OBSERVATIONS AND TESTS TO BE MADE BEFORE CLIMBING OR WORKING AT JOINT USE POLES

1.002 This addendum is issued to provide an alternate method of using the B Shunting Capacitor with B Voltage Testers which have tape reinforced ferrules.

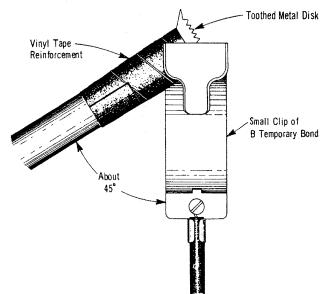
Add the following to Paragraph 5.02(h)(2)

If the metal cap or ferrule of the B Voltage Tester has been tape reinforced, attach the large clip of the temporary bond to the metal terminal of the capacitor; attach the small clip to the toothed metal disk of the B Voltage Tester as shown below.
